Title - Sujet Palace Grand Theatre Foundation Rep	
Solicitation No. - N° de l'invitation EZ899-152418/A	Amendment No. - N° modif. 004
Client Reference No. - N° de référence du client	Date 2015-06-29
GETS Reference No. - N° de référence de SEAG PW-\$PWY-022-7522	
File No. - N° de dossier PWY-5-38030 (022)	CCC No./N° CCC - FMS No./N° VME
Solicitation Closes - L'invitation prend fin at - à 02:00 PM on - le 2015-07-08	Time Zone Fuseau horaire Pacific Daylight Saving Time PDT
F.O.B. - F.A.B. Plant-Usine: <input type="checkbox"/> Destination: <input checked="" type="checkbox"/> Other-Autre: <input type="checkbox"/>	
Address Enquiries to: - Adresser toutes questions à: Arthur (PWY), Carolyn	Buyer Id - Id de l'acheteur pwy022
Telephone No. - N° de téléphone (604) 775-6667 ()	FAX No. - N° de FAX (604) 775-6633
Destination - of Goods, Services, and Construction: Destination - des biens, services et construction: Parks Canada - Palace Grand Theatre - Dawson City, YT

Amendment 004

PROJECT NO. R.068835.001
PALACE GRAND THEATRE FOUNDATION REPLACEMENT
DAWSON CITY, YUKON TERRITORY

ADDENDUM No. 2
Jun 26, 2015

SK-MOL
144902132

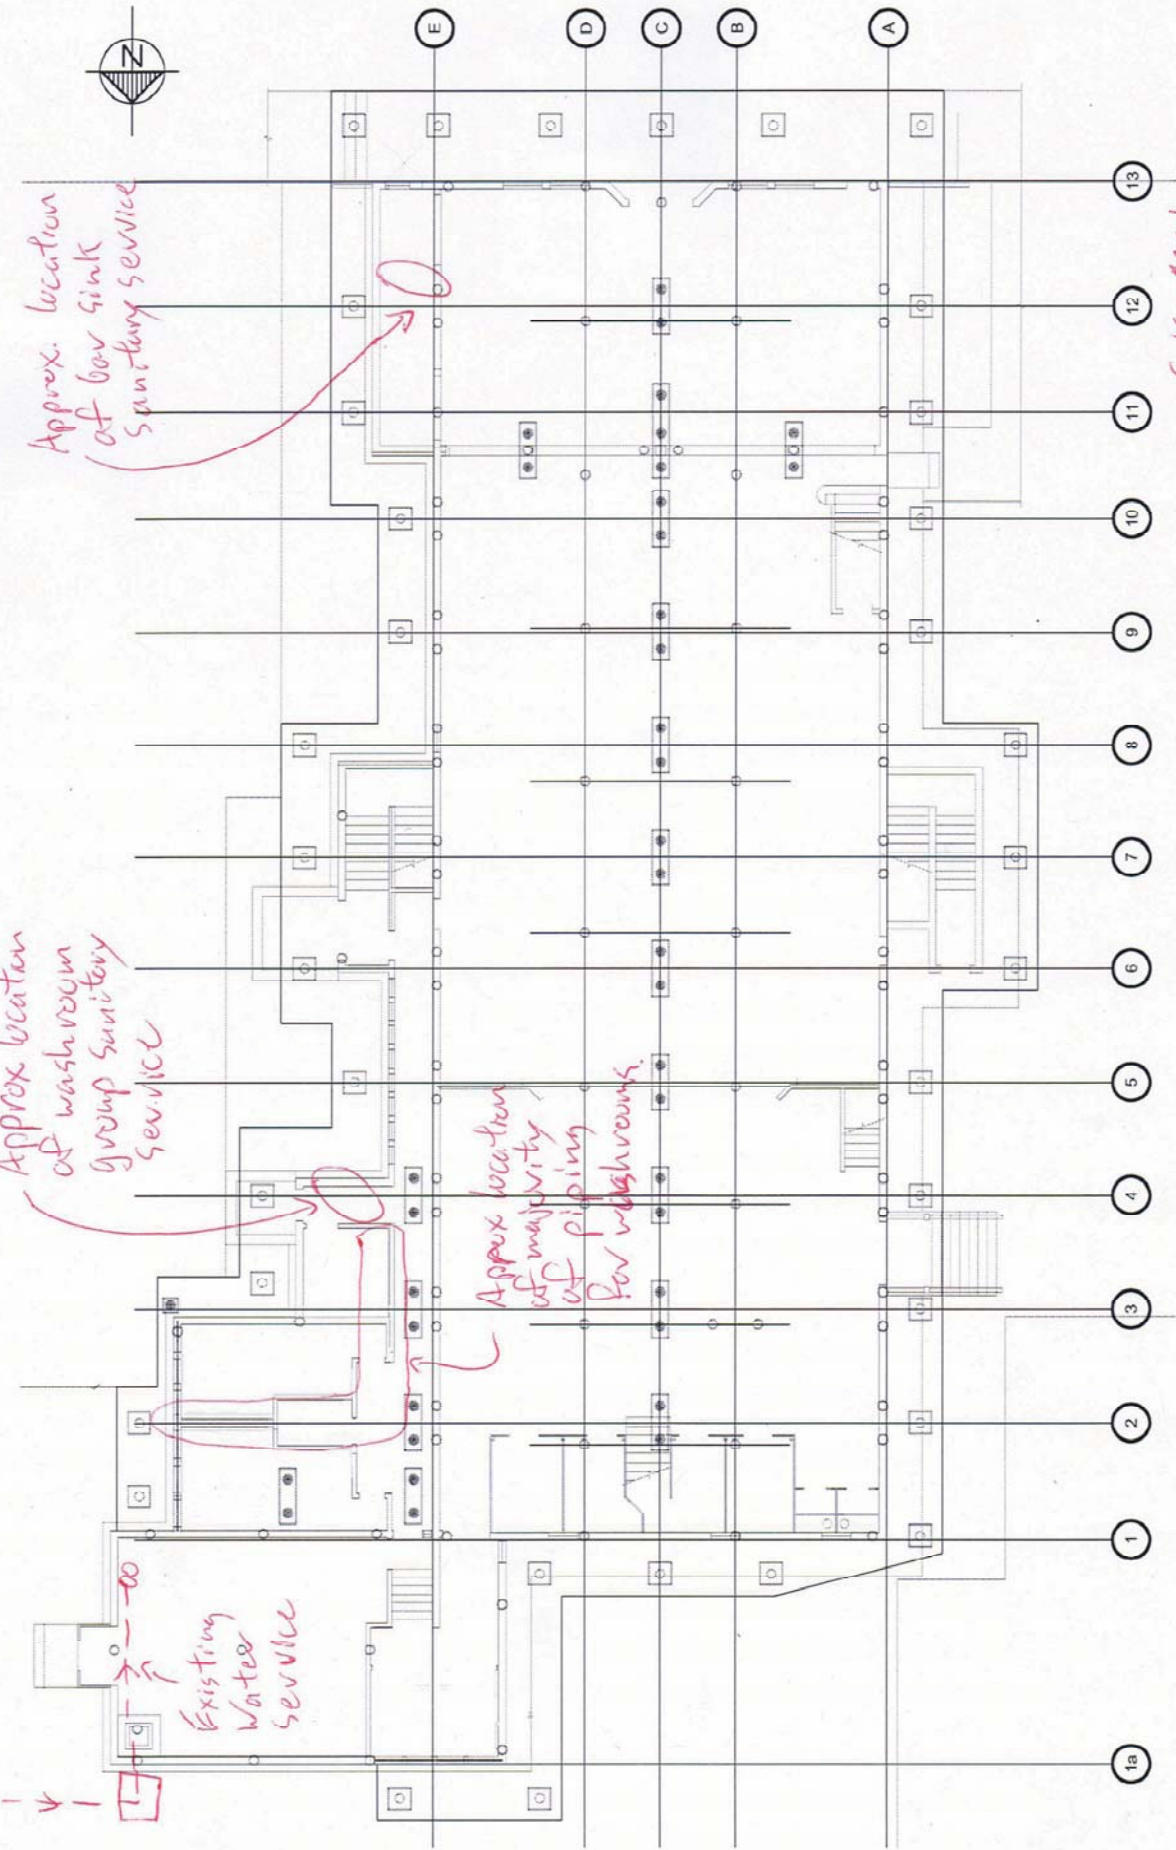
ITEM #	DESCRIPTION	RESPONSE
M029.1	<p>Per emailed questions from bidders, dated June 18, 2105:</p> <p>2. Please provide details on existing sanitary and water services- size, locations, material etc. Provide clarification on disconnection and reconnection of both sanitary and water lines. Will plumbing in existing bathrooms need to be redone?</p> <p>3. General scope (01 11 55 item 1.2) has remove and re-install existing mechanical and electrical. Drawings show to remove and dispose of existing HVAC. Please clarify what re-installation is required.</p> <p>4. Please clarify scope of sprinkler re-installation.</p>	<p>Responses are as follows</p> <p>2. Refer to attached sketch SK-M01 for sanitary and water services locations. Sanitary services are ABS-DWW and water service is steel. It is expected sanitary services under washrooms will require minimal if any modification to accommodate foundation replacement.</p> <p>3. No mechanical re-installation required. Work to be completed under Tender 3.</p> <p>4. Sprinkler re-installation not required.</p>

Approx. location
of bar sink
sanitary service

Approx location
of washroom
group sanitary
service

Approx location
of majority
of piping
for washrooms.

Existing
Water
service
